THQ

Proposed Amendments to LPA Ref. 121270/00/2018

THG1(REP)A005_C

Airport City Manchester

Approved Planning Drawing 2020 - North Elevation

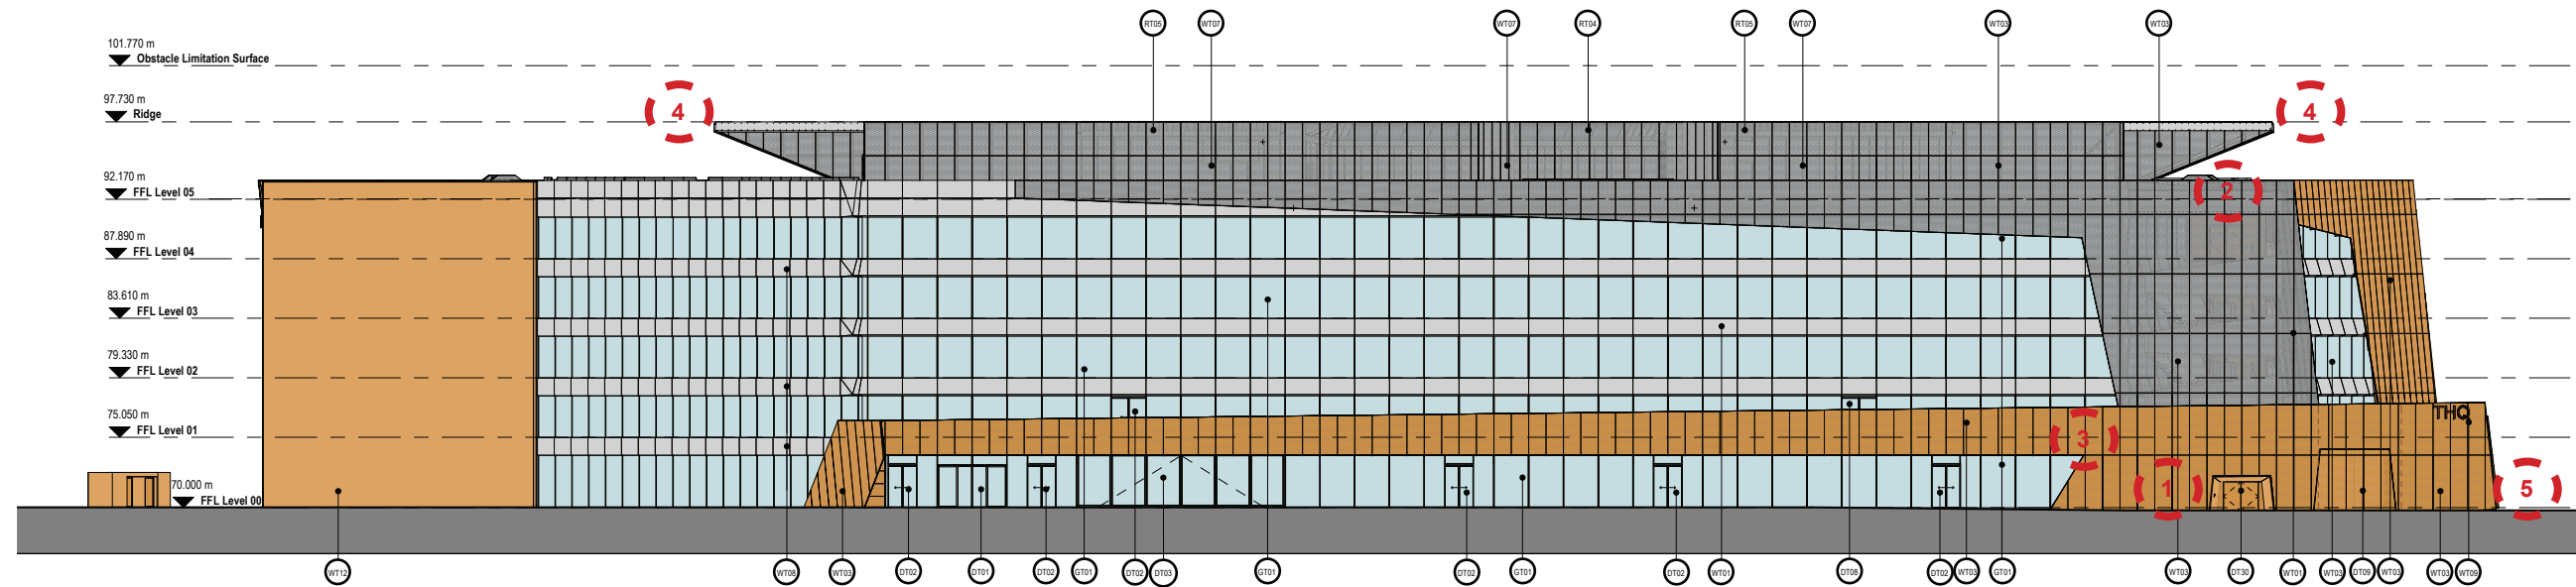
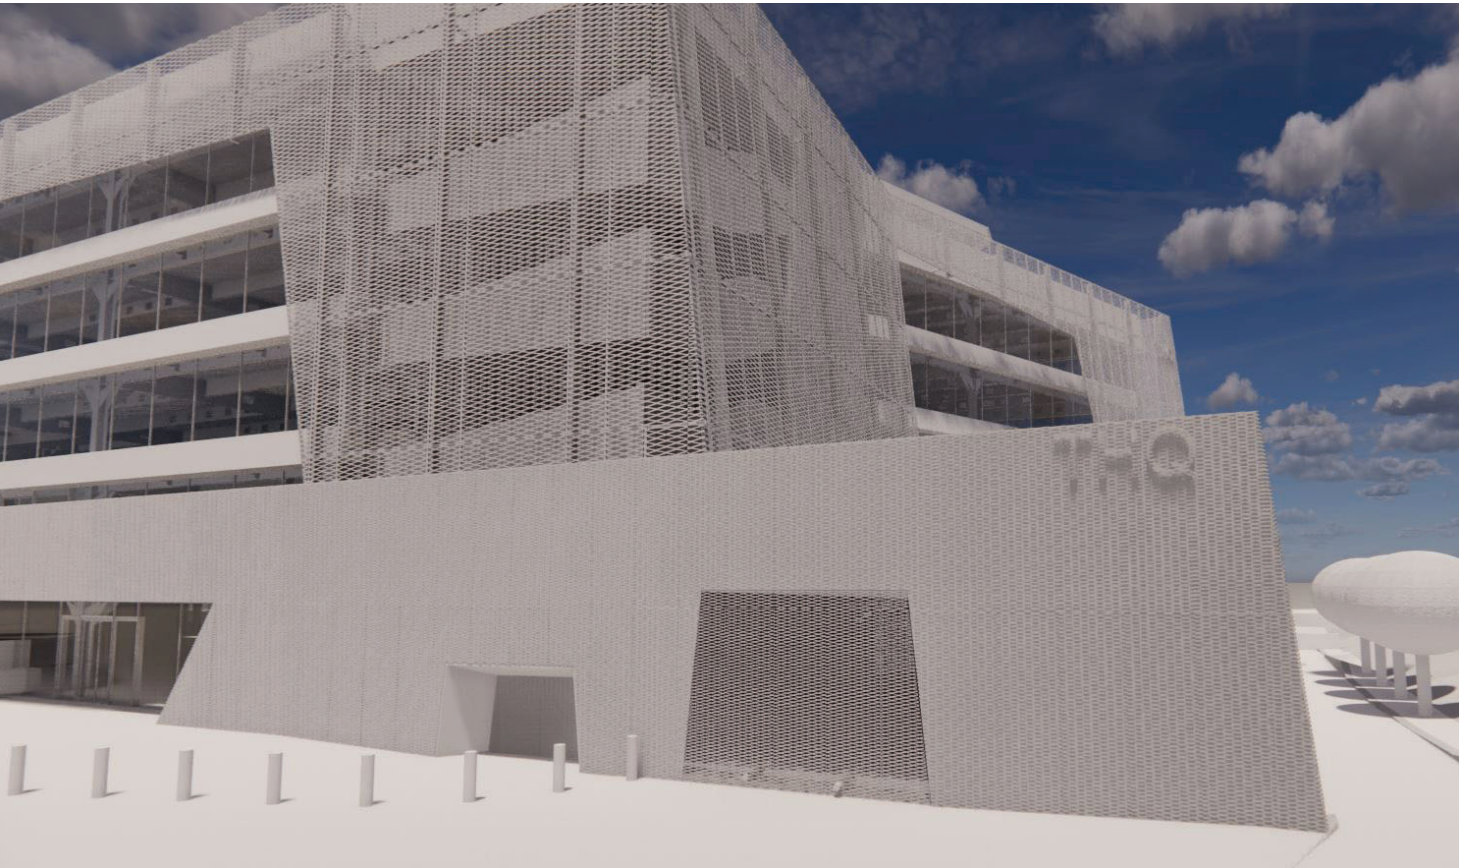
Changes to elevation

1. Escape door configuration updated
2. Change to parapet behind mesh cladding
3. Removal of concierge drop off point and canopy
4. PV angle change
5. HV transformer room doors omitted

1 Escape door configuration updated

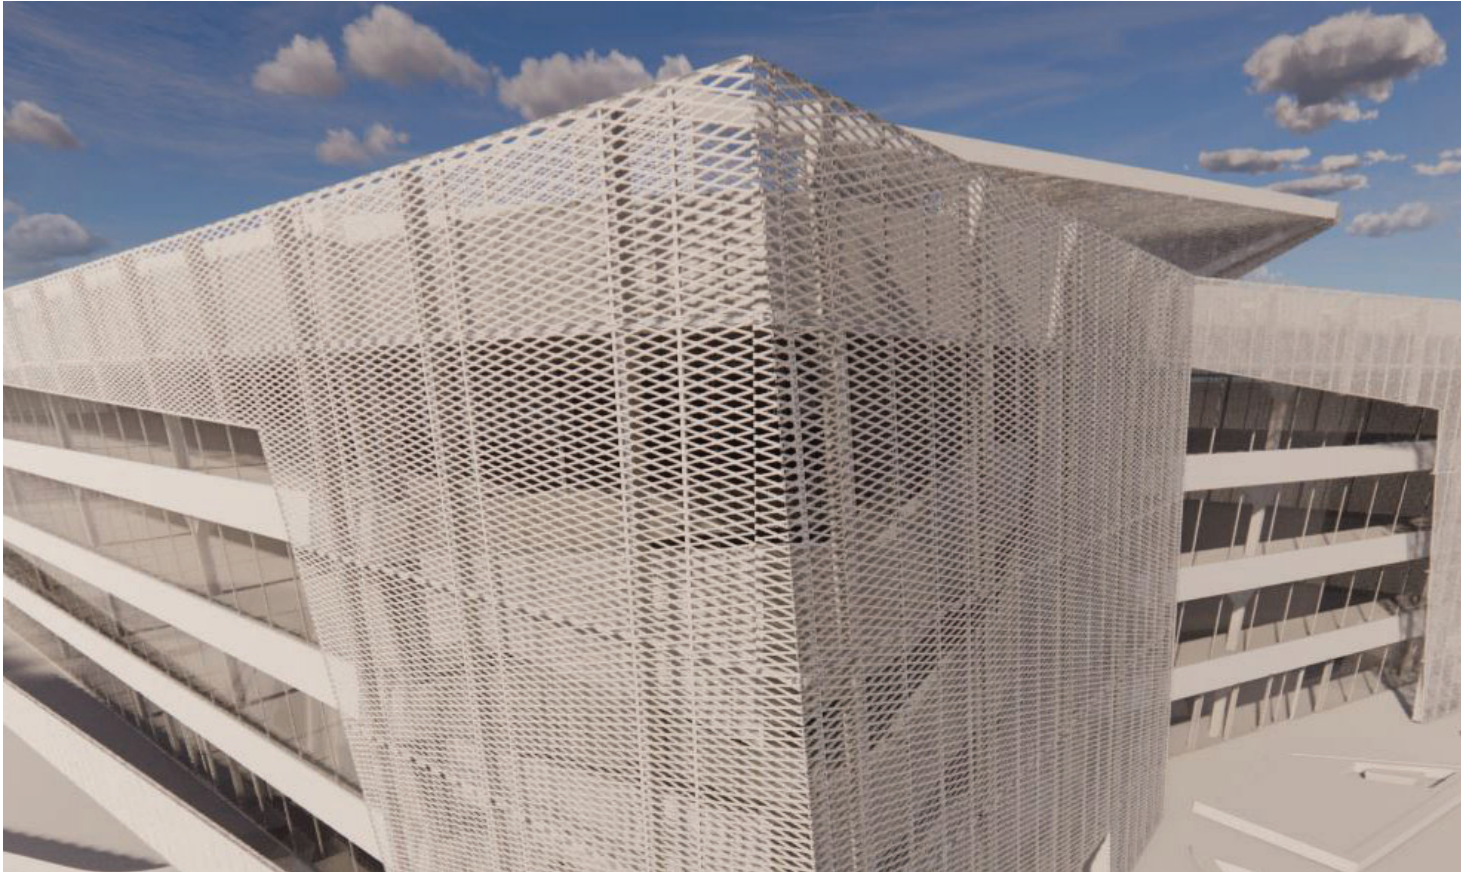
Escape stair door recessed into mesh facade

With the omission of the canopy to the concierge drop off, numerous services that were incorporated into this structure have had to be re-housed. Taking precedent from other doors within the facades of the building and the MSCP, a recessed portal configuration has been introduced to allow emergency lighting and door access controls to be incorporated into the panel system rather than mounted on the face of the mesh.

2 Change to parapet behind mesh cladding

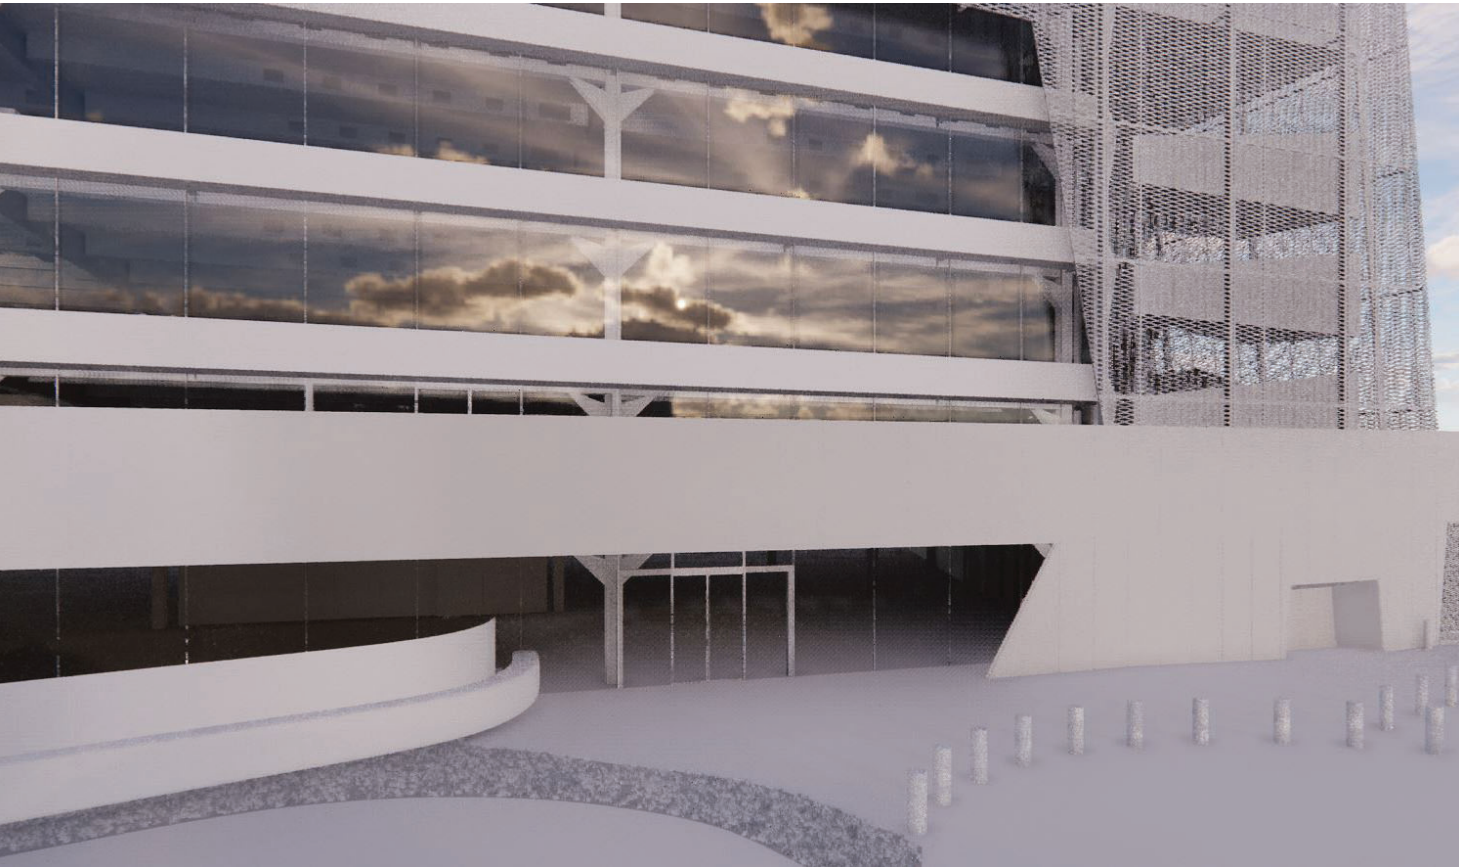
Parapet remodelling to western stair

To ensure the dynamic nature of the facade is maintained to all elevations, there has been a subtle change to the parapet to the wester stair. The parapet, (previously horizontal) now falls at an angle to the corner point of the north and west facades. This angle works with the spandrel panels that clad the stair landings below and gives the impression of the parapet is diminishing in height, thus making it appear less obtrusive.

3 Removal of concierge drop off point and canopy

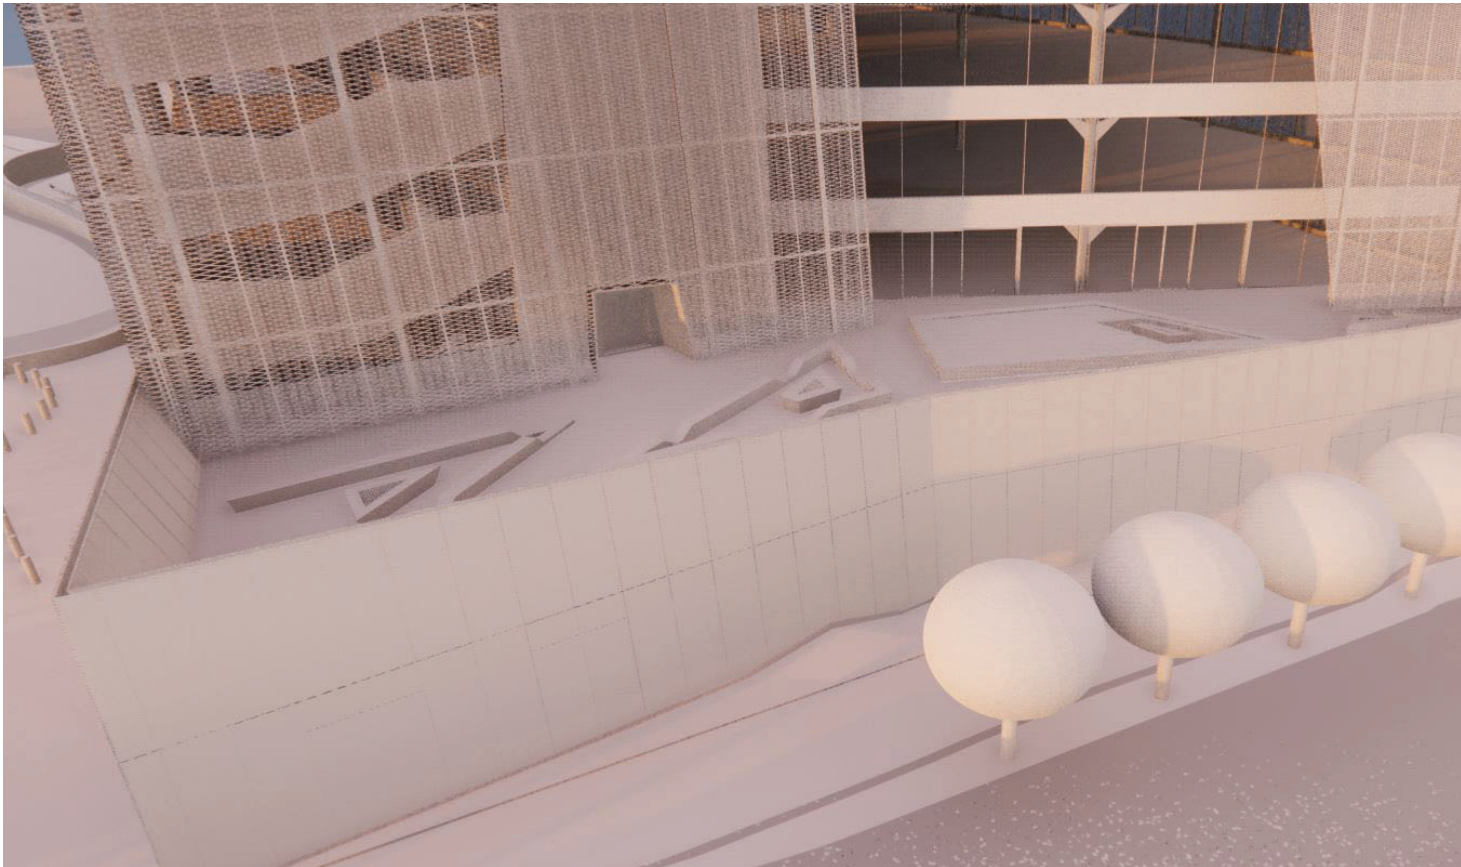
Removal of canopy to concierge drop off

The removal of the canopy opens up the glazed elevation to the north facade to allow views out of the office towards the central amenity space and the amended adjacent Hut Garden.

5 HV transformer doors omitted (west facade)

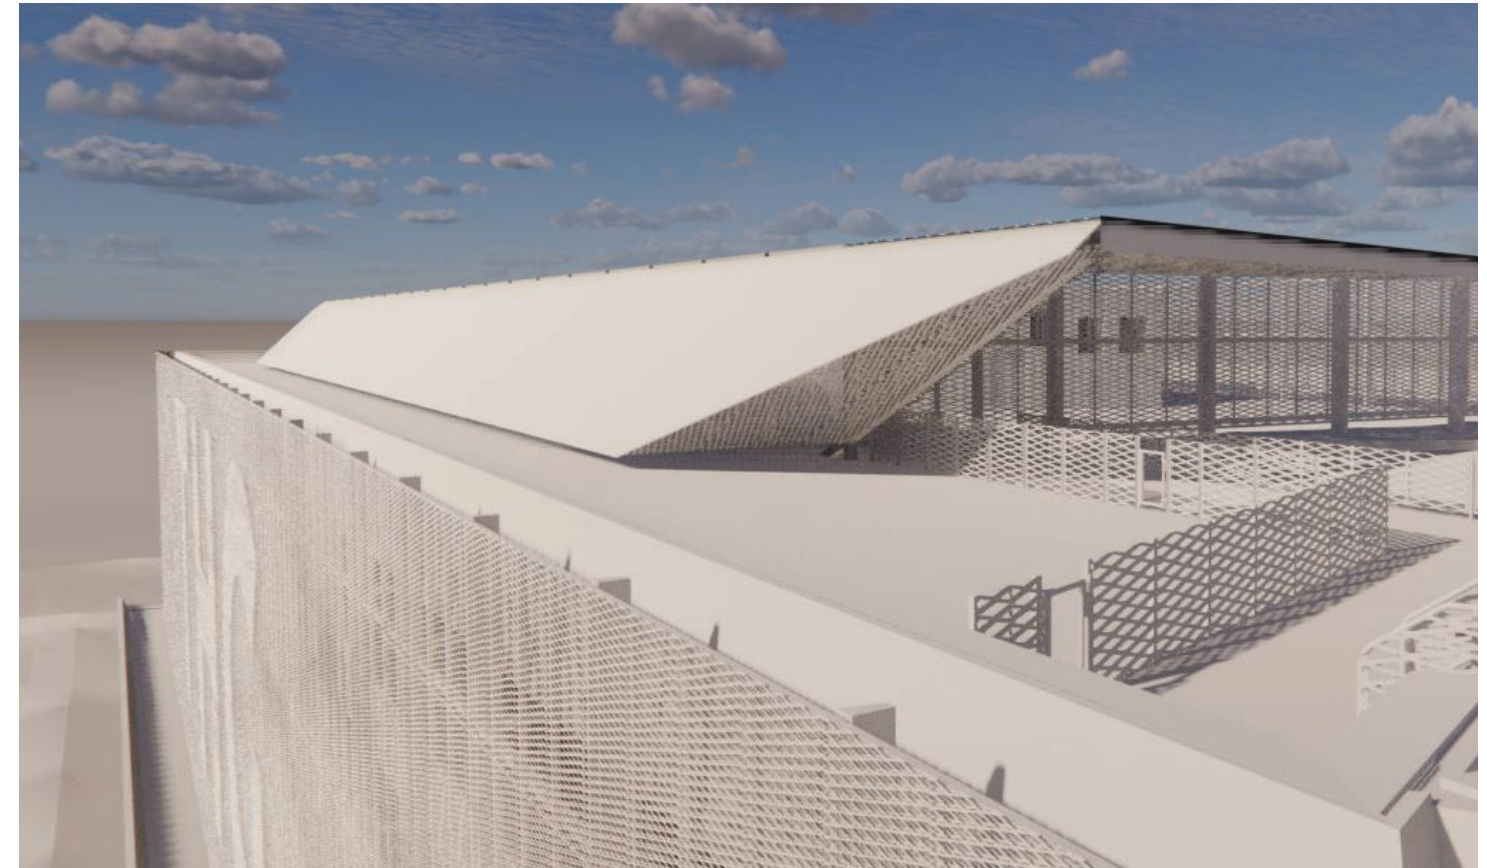
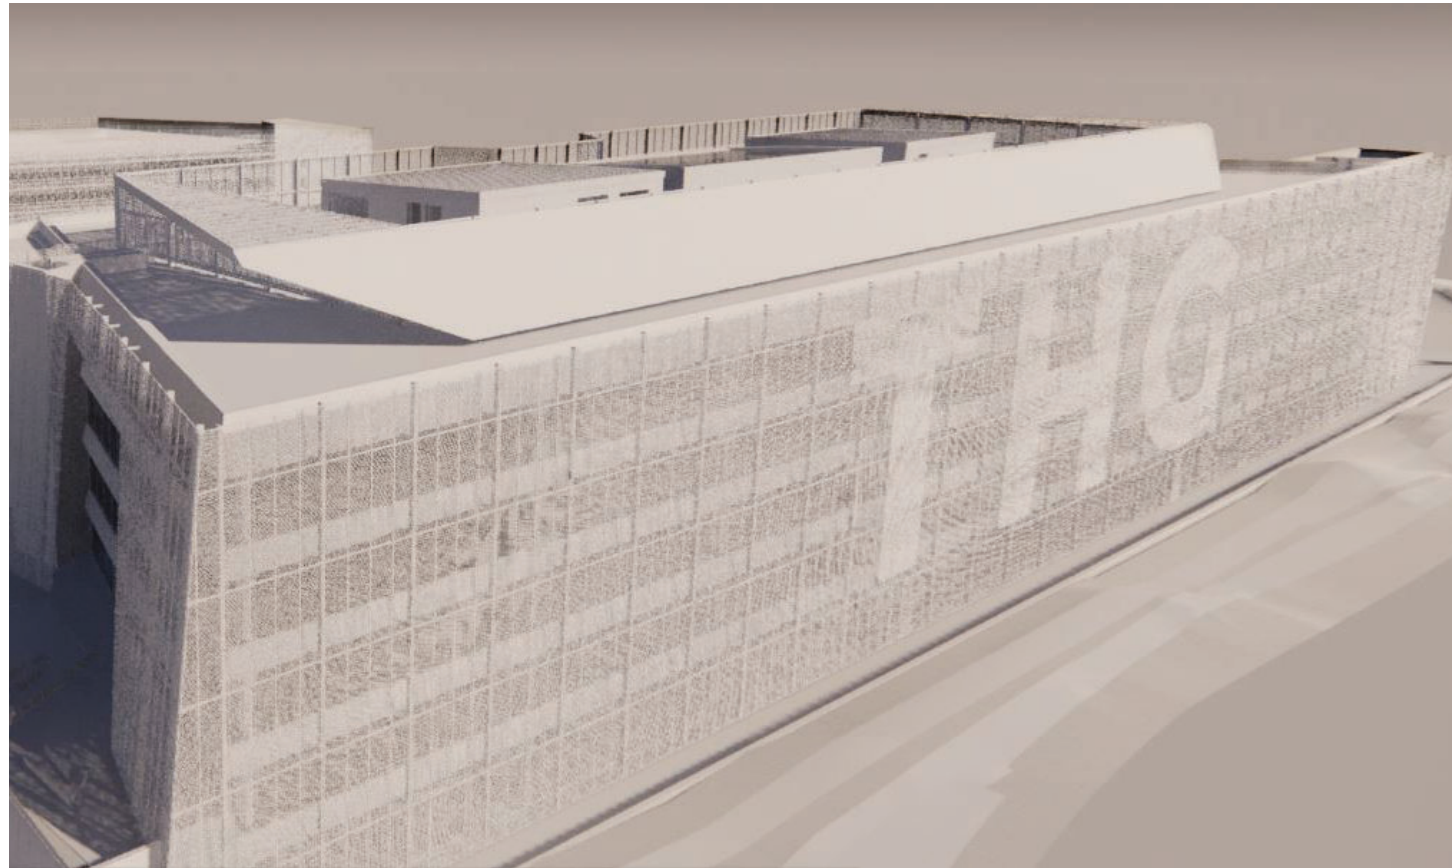
Omission of 2 doors to HV transformer rooms

Due to a change in the approach to sustainable design by THG and efficiencies adopted in the M&E strategies the rooms previously allocated for the HV transformers at ground floor have been transformed into future storage for battery cells. These stores will be accessed from within the service bay for security reasons, resulting in the removal of the doors to the western facade. The relocation of the HV transformers from ground to roof also provide future flexibility for future phases of THG’s masterplan to connect directly into the first phase office building.

Approved Planning Drawing 2020 - East Elevation

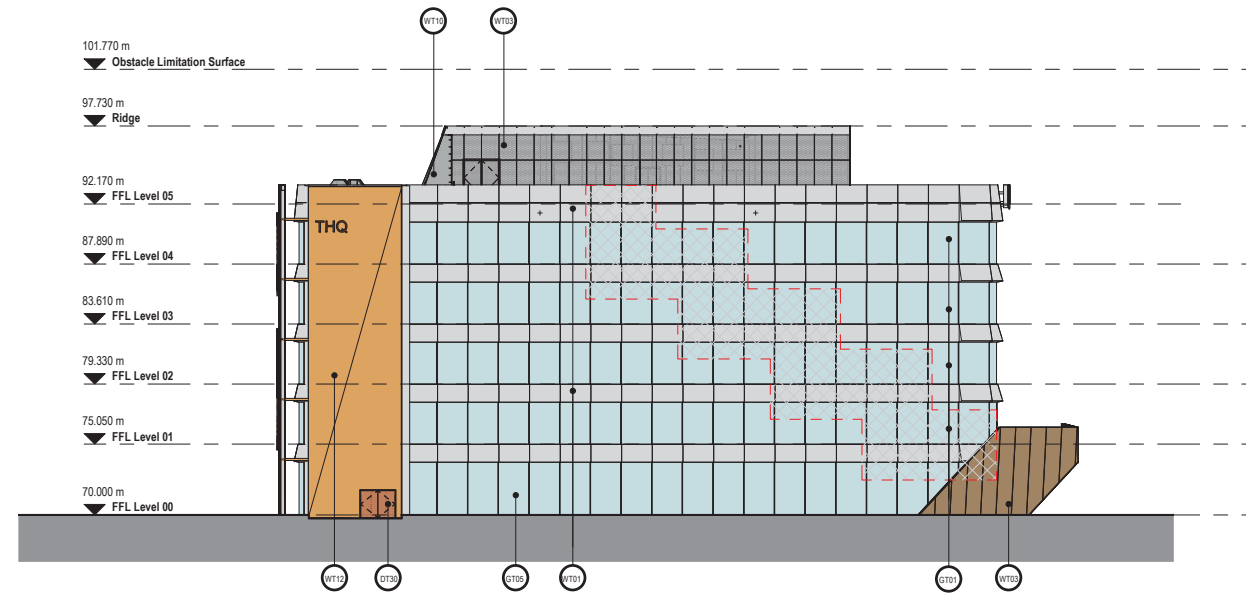
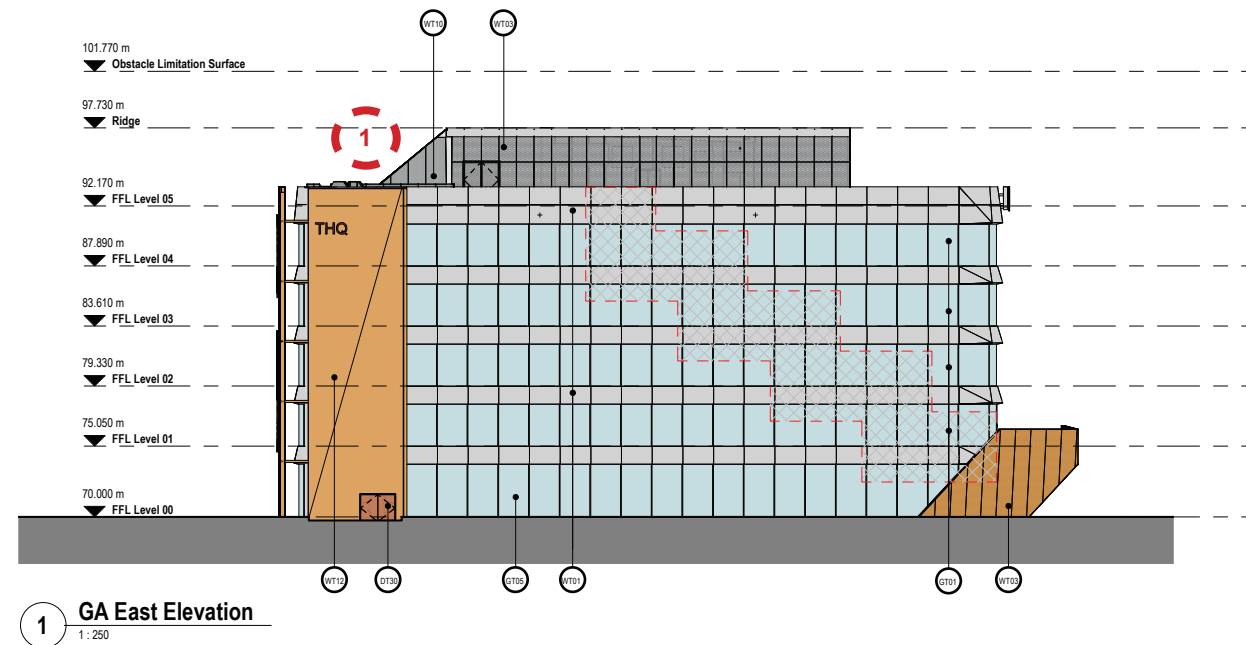
Changes to elevation

1. PV angle change
